# UNITED STATES PATENT AND TRADEMARK OFFICE

APPLICATION NO.	FILING DATE	FIRST NAMED INVENTOR	ATTORNEY DOCKET NO.	CONFIRMATION NO.
09/971,131	10/04/2001	James C. Tuthill	21488/04040	4066
24024	7590	09/22/2004	EXAMINER	
CALFEE HALTER & GRISWOLD, LLP 800 SUPERIOR AVENUE SUITE 1400 CLEVELAND, OH 44114			ROSS, DANA	
			ART UNIT	PAPER NUMBER
			3722

<b>Office Action Summary</b>	Application No.	Applicant(s)	
	09/971,131	TUTHILL, JAMES C.	
	Examiner	Art Unit	
	Dana Ross	3722

### **DETAILED ACTION**

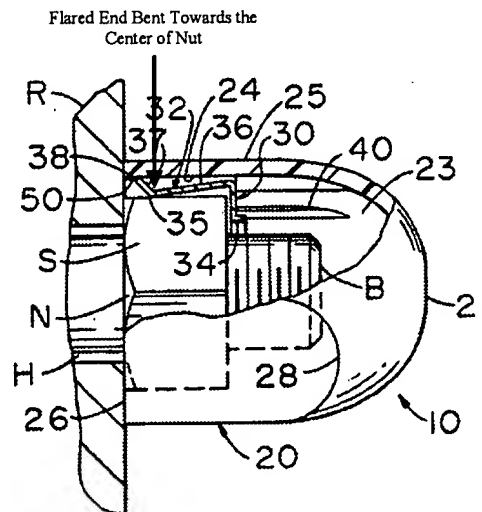
Regarding claim 8, Bias teaches a base (31), peripheral section (32, 36), central aperture (33) wherein the peripheral section includes fingers which define windows (see figures 7 and 9). The fingers each include a “flared end” (see lead lines 37 and 38) “bent” toward the center of the retainer (see figure 3 wherein cap 21 is installed, the ends of the fingers are “bent”).

Regarding claim 13 and 16, Bias discloses a retainer (30) comprising an integral base section (31) and a generally perpendicular peripheral section (32) maintaining a cup-shaped configuration while in place over the nut (N). The base section (31) has a central aperture (33) and the peripheral section (32) has an interior surface that includes a plurality of fingers which define one or more longitudinal windows therebetween (see figures 8A and 9). The fingers having nut-engaging surfaces on the interior surface of the peripheral section (this is shown most clearly in figure 3 above).

Regarding claim 24, Bias teaches the inwardly extending portions are flared ends of fingers upon the peripheral section (see fig. 3 in the above 102 rejections).
